SEWAGE DISPOSAL SYSTEM

DEPARTMENT OF HEALTH AND MENTAL HYGIENE

SUBDIVISION _____ LOT _____ ROAD 10625 Gorman Road

REPAIR - PURPOSE - SEPTIC TANK HAS COLLASPED.

R57349

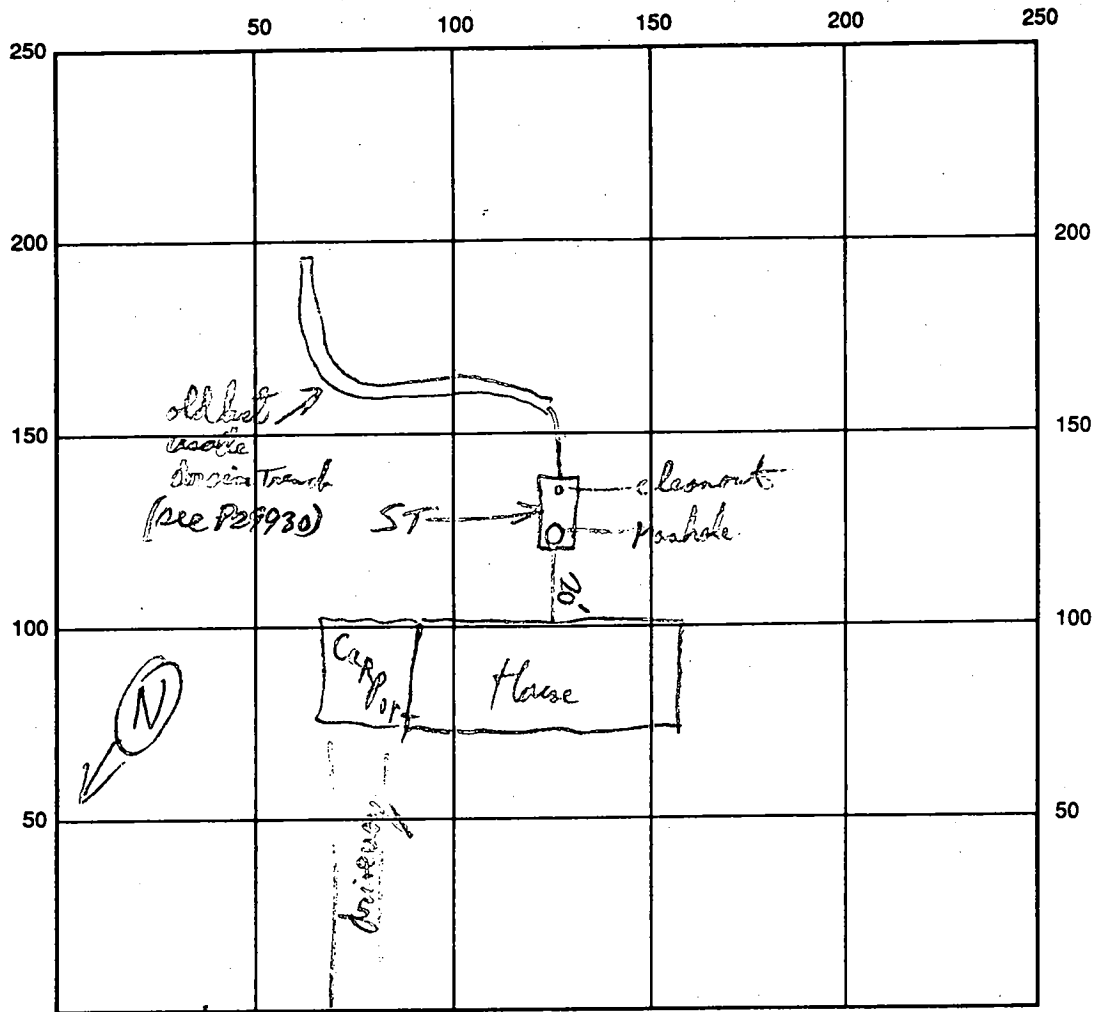
REMARKS: No evidence of Septic Drain field problem. entire area is enclosed - soils are excellent for Septic system -
pro recent filling - No evidence of seepage) and soils are excellent for Septic system.
Replace for septic tank which covered last week. - also old connections pipes are being
replaced with cast iron from House to S.T. and sched 40 PVC from Tank to old septic line
OK to Cover Riff 10/24/96

P
29930

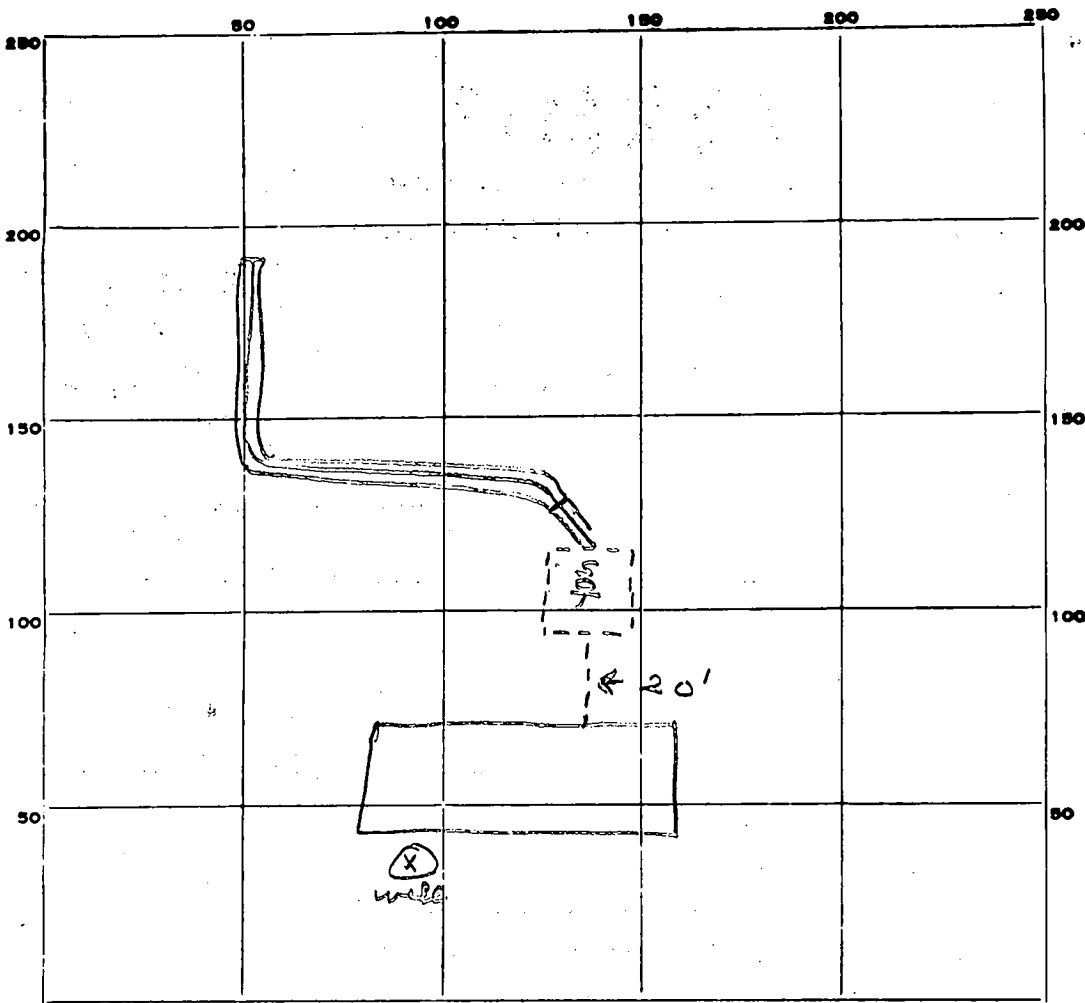
REMARKS 6/18/79 - OK given to owner work after
gravel & pipe added. Owners, Mr. Hamlin, will
give written verification of gravel depth. J
